STATE OF MAINE
DEPARTMENT OF TRANSPORTATION
☐ Approved ☒ Returned for Corrections
SEP 14 1997
☒ Approved as noted ☐ Rejected

DESCRIPTION Timber Railing
PROJECT Winter St. Bridge Over Maine DOT Railroads
LOCATION BATH, MAINE SAGadahoc COUNTY
DESIGNER _____
CUSTOMER MAINE DEPT. OF TRANS.
DRAWN BY ARK/KND DATE 8-25-97 JOB NUMBER 77-76 DWG. NO. E1
CHK'D BY _____ DATE _____

GLULAM TIMBER HANDRAIL

GLULAM TIMBER GUARD RAIL				
TOLERANCES (EXCEPT AS NOTED)		REVISIONS		
DECIMAL	NO.	DATE	BY	
2	1			
FRACTIONAL	2			
2	2			
ANGULAR	3			
2	3

15-Post MK - C1

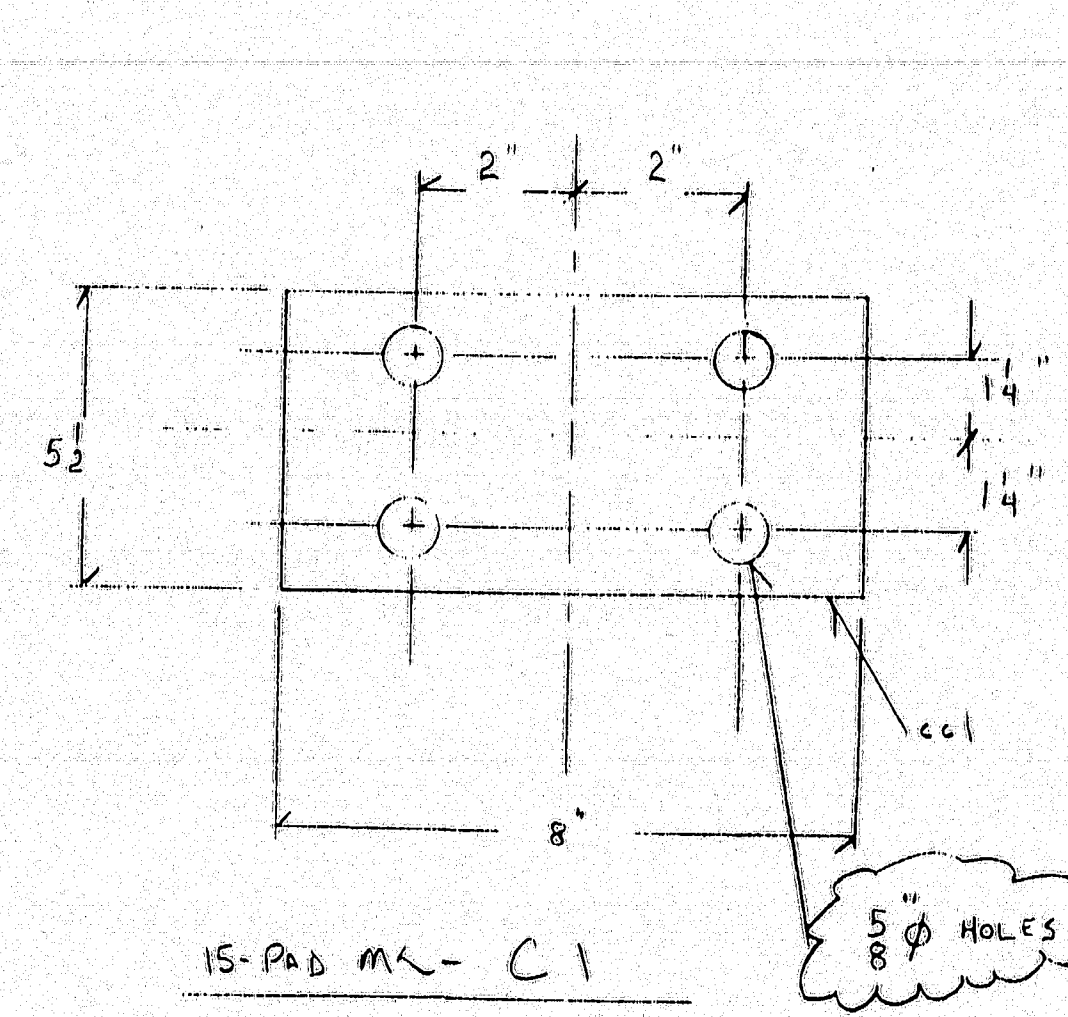
17. ME STD 507.03(Cb) add 1090 to allow leveling

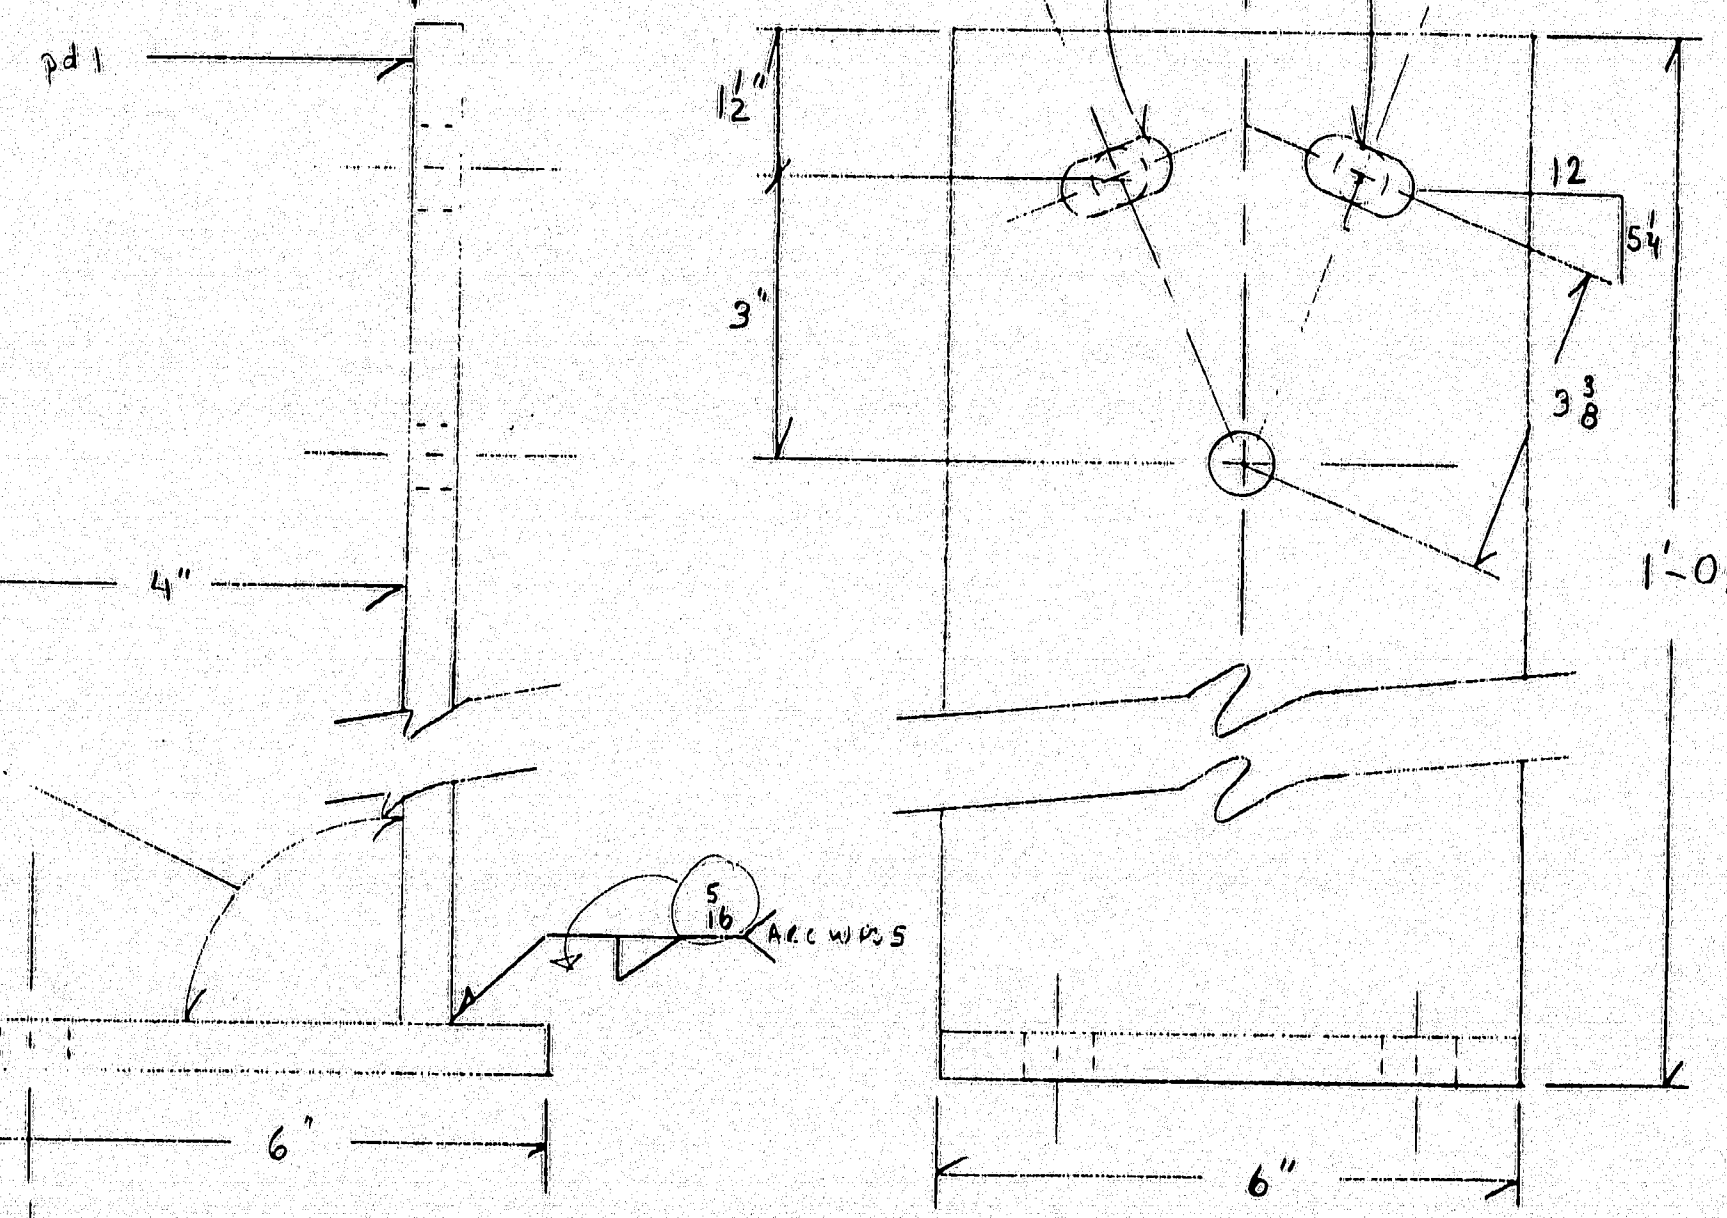
What do you intend to use?

Hardware also galvanized ASTM A153

Use 9/16" and get 92° - 41"

Use 1/4" and get 91° - 11"

This color is brown

Use 1/4" 2 Use 9/16"

3-ANCHORS - MK-G1

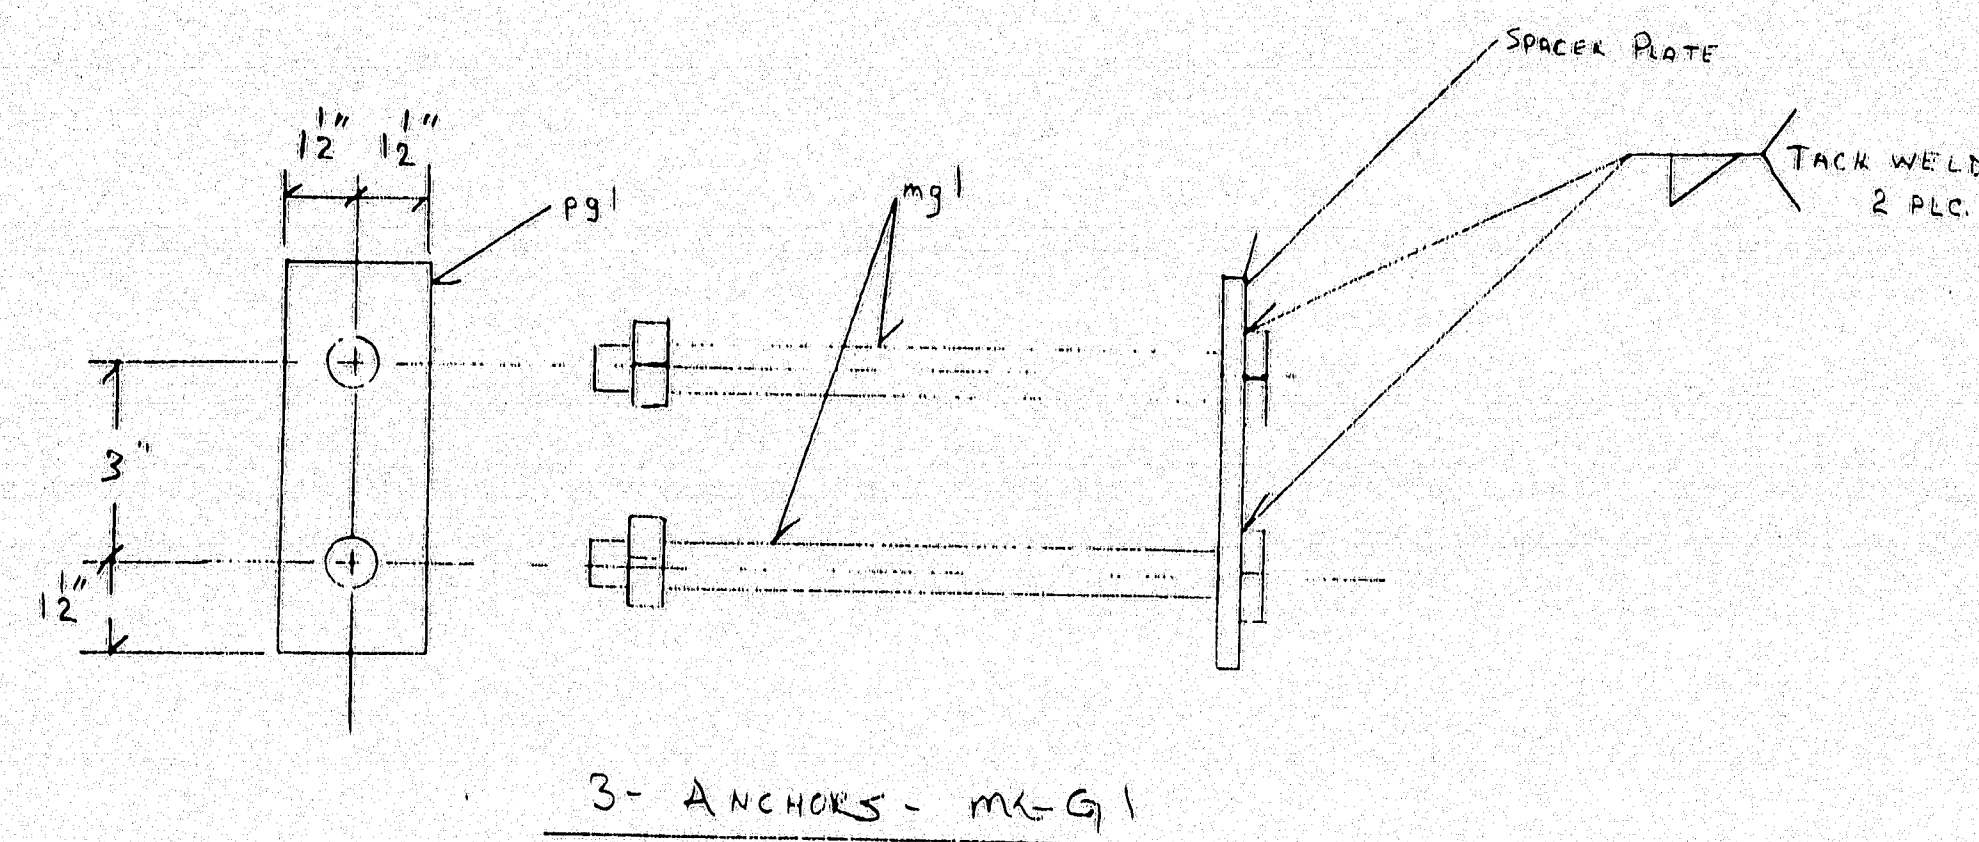
APPROVE NOTE: Please verify position of anchor

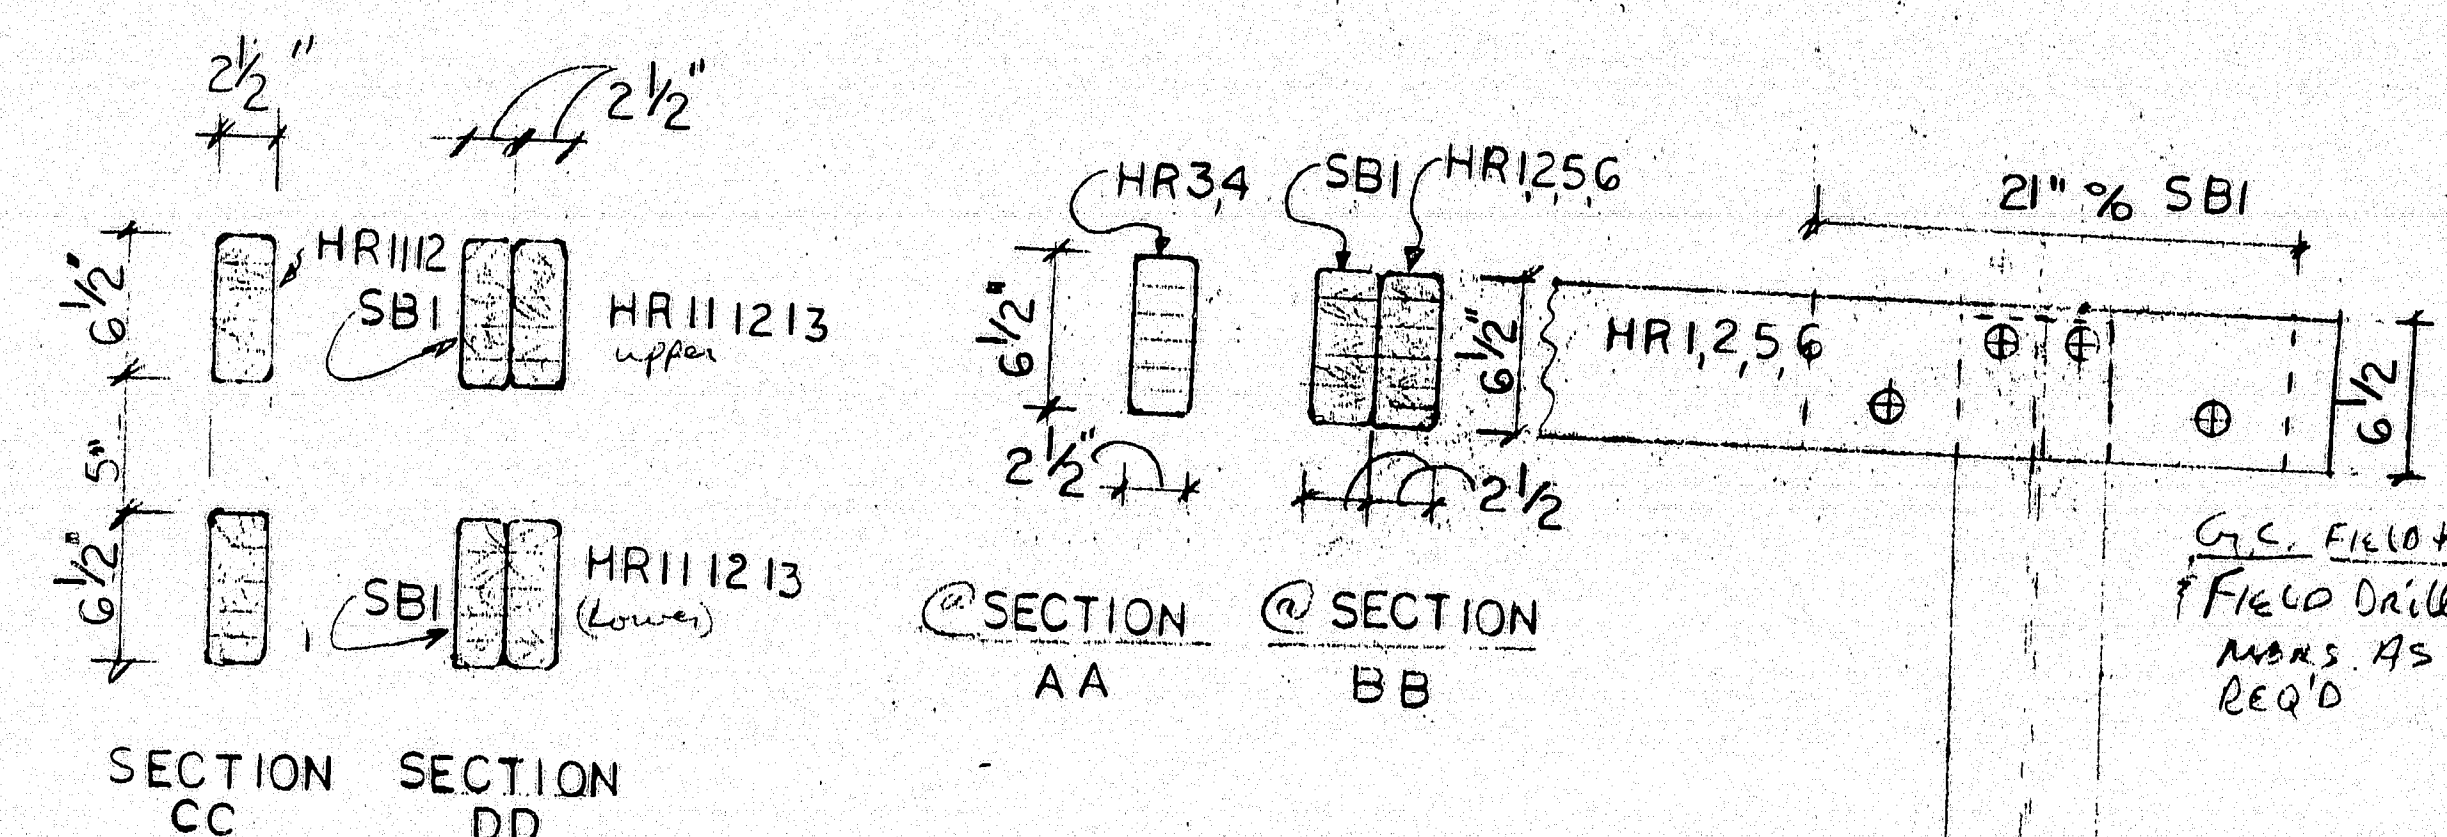
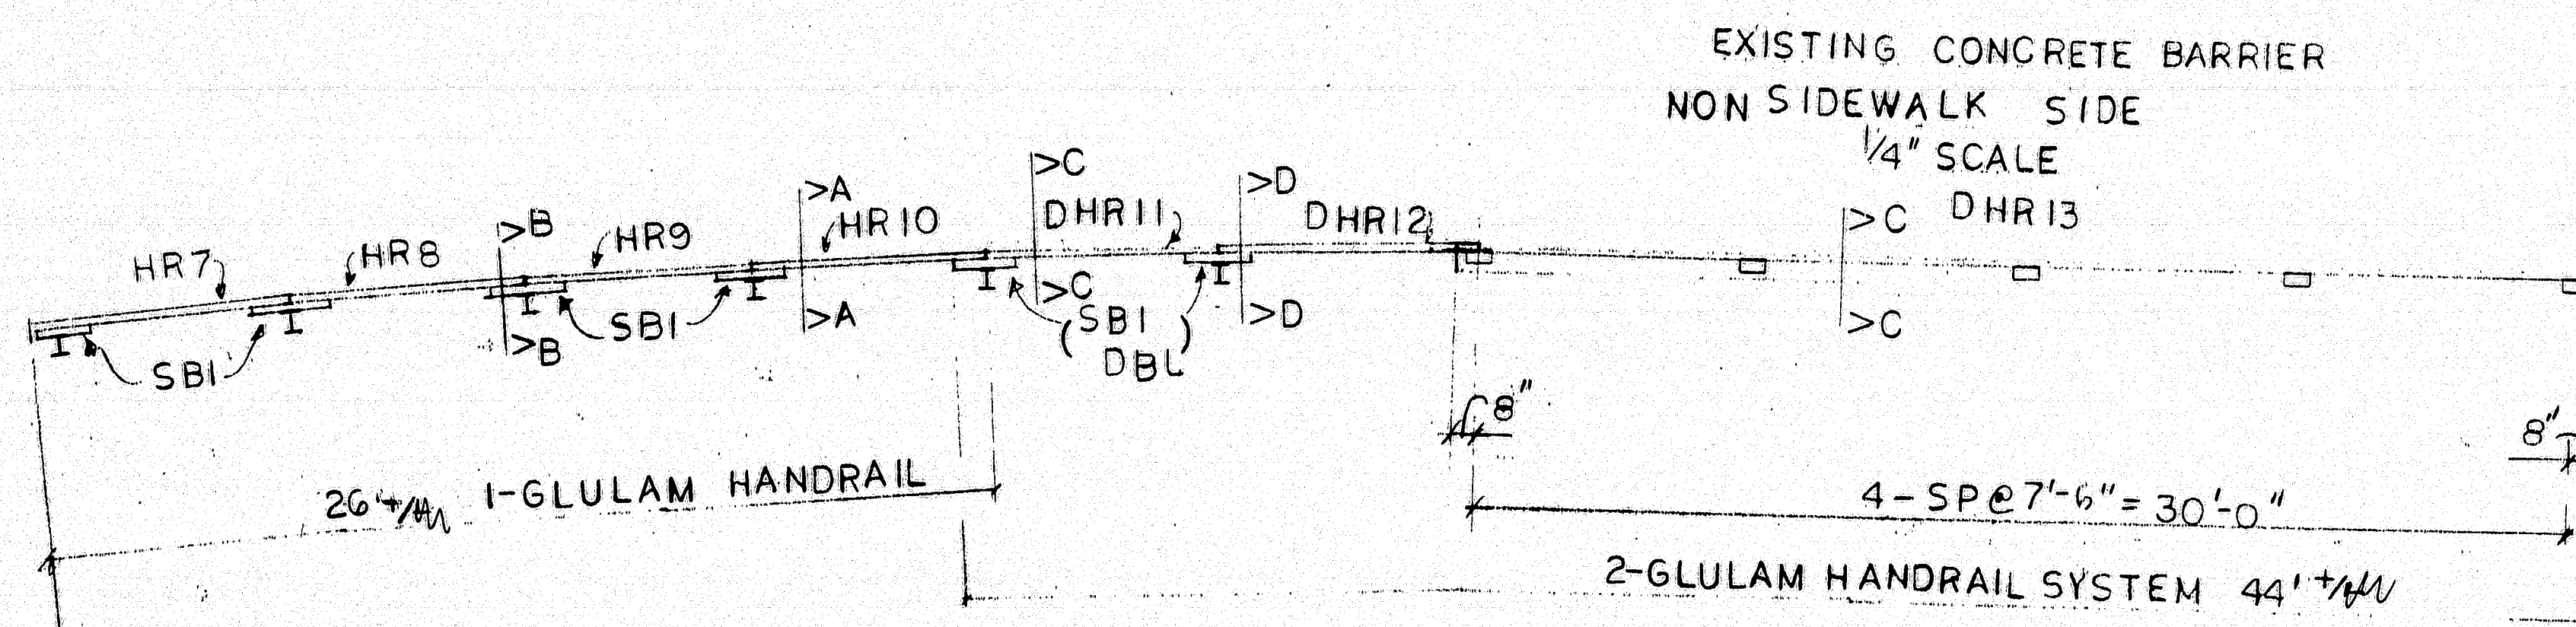
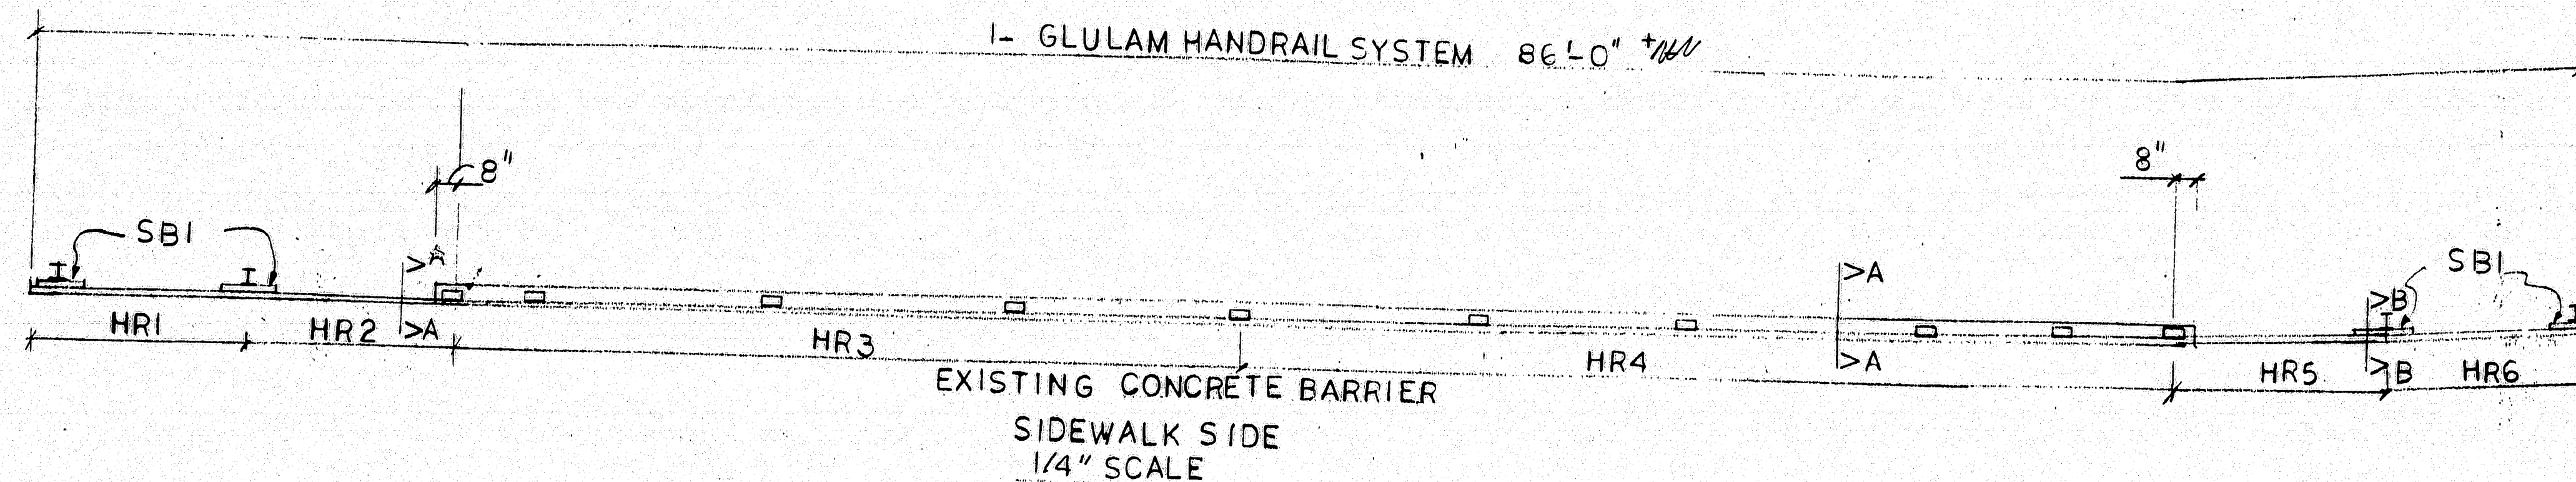
Each handrail length
shall be attached to
a minimum of
three posts.
See Note 13 of
Set 4 & 4 Det. Day.
Combine some
lengths?
